Subject: Update to February 25, 2026 Letter Regarding Ballard Fuel Cell External Coolant Leak

Working with Ballard, we originally thought and conveyed that a supplier change made in early 2025 to the manifold-channel gasket was responsible for the leaking conditions. This was based on an observation that the 2026 channel gaskets exhibited better “fitment” properties than the previous 2025 version. Through subsequent testing and analysis, we have learned that there are 3 primary root causes that can influence how fully the manifold and gasket seat when bolted together. This reduced seating can create localized areas where sealing performance is diminished, potentially contributing to the leak condition observed.

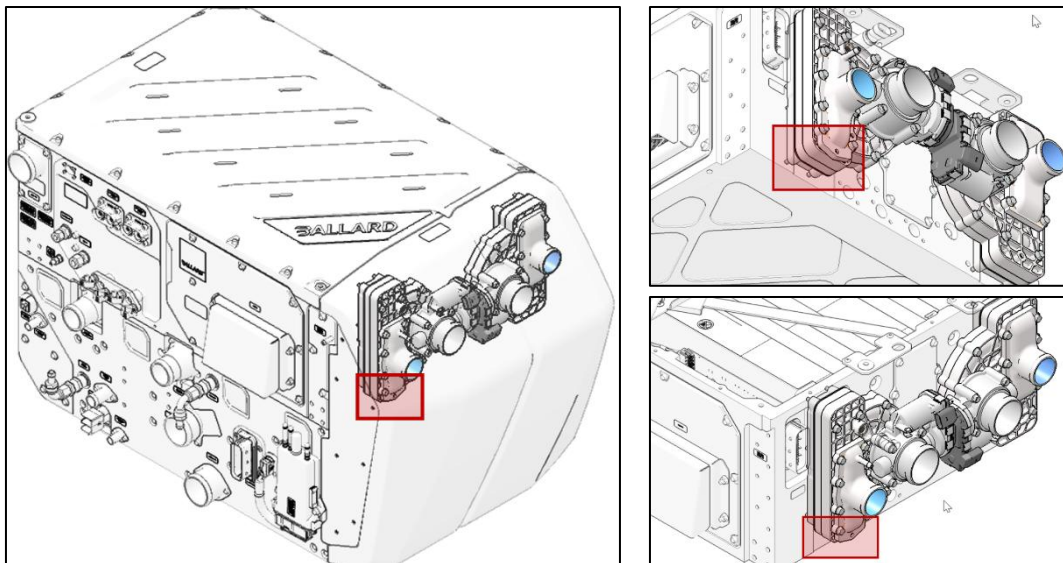
- Returned parts to Ballard exhibited tooling flash on the manifold. This tooling flash is located within the manifold channel where the gasket seats.
- Excess volume of webbing on the gasket creates a hydraulic locking condition where the manifold does not have space for expansion in the corners of the gasket creating a “squeeze out” condition of the EPDM.
- The gasket squared profile presents a configuration in which, under certain conditions, the EPDM gasket volume may approach the limits of the available channel space depending upon assembly conditions.

While campaign logistics are being finalized, customers should continue to follow their standard preventive maintenance practices, including routine inspections for coolant leaks. The below pictures (shaded area specifically) identify the area where these coolant leaks have been found.

Through a combination of removing the tooling flash from the manifold and reworking the EPDM gaskets to remove excess material in the corners of the gasket, we have been successful in eliminating the leak. This has been verified on over 30 buses.

As a permanent corrective action, Ballard has utilized existing certified tooling to produce parts with refined profiles that improve channel fit. The updated design incorporates webbing that supports controlled gasket expansion in the manifold corners. These parts were produced in silicone based on the tooling already available for this material. Ballard is also ensuring the manifolds do not have the tooling flash.

We are confident that eliminating tooling flash, combined with either reworked EPDM gaskets or silicone gaskets, provides an effective corrective action to prevent leaks and allows buses to be released for shipment. Both corrective actions involve torquing the manifold bolts to 8Nm, which is the specification. We originally thought there was merit to increasing the torque from 8Nm to 11Nm but by addressing the root causes, we find the increased torque is no longer needed.
